Process Sheet

Customer	: CU-DAR001 Dart Helicopters Services		Drawing Name	: TUBE ASSEMBLY	
Job Number	: 39644		Part Number	: D2003043	
Estimate Number	: 10923		Drawing Number	: UNDER REVIEW	
P.O. Number	:		Project Number	: N/A	
This Issue	: 02/06/2008 S.O. No. :		Drawing Revision	: B	
Prsht Rev.	: NC		Material	:	
First Issue	: / /		Due Date	: 03/06/2008	
Previous Run	: 37325		Qty:	5 Um: Each	
Written By	:				
Checked & Approved By	: JLD 08.6.02				
Comment	: Est. B 00.01.12 Re-format EC

DESIGN	DRAWN BY	DART AEROSPACE LTD HAWKESBURY, ONTARIO, CANADA	
CHECKED	APPROVED	DRAWING NO.	REV. B
DATE		D2003	SHEET 1 OF 2
99.06.08		TITLE 206 CABIN HEATER TUBE ASSEMBLIES NTS	
A	90.04.09	NEW ISSUE	
B	99.06.08	UPDATE PER TEMPLATES; ADD P/N'S; 0.025 TUBING NOW 0.035 (TSR1049)

DESIGN	DRAWN BY	DART AEROSPACE LTD HAWKESBURY, ONTARIO, CANADA
CHECKED	APPROVED	DRAWING NO. D2003
DATE		TITLE 206 CABIN HEATER TUBE ASSEMBLIES NTS

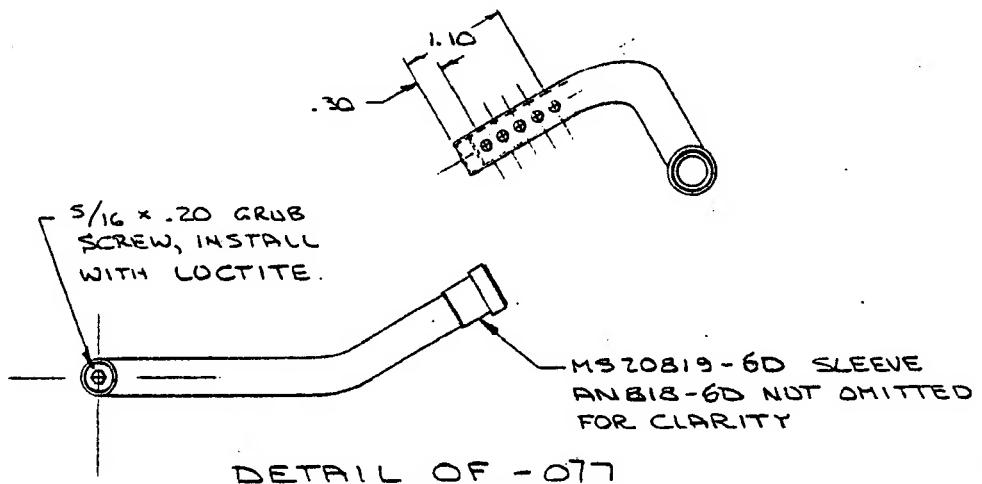
CONFIRM W/ENG. CUT LENGTH
OF TUBING

UNDER REVIEW100.08.21 CB
Some flat lengths
not wrong
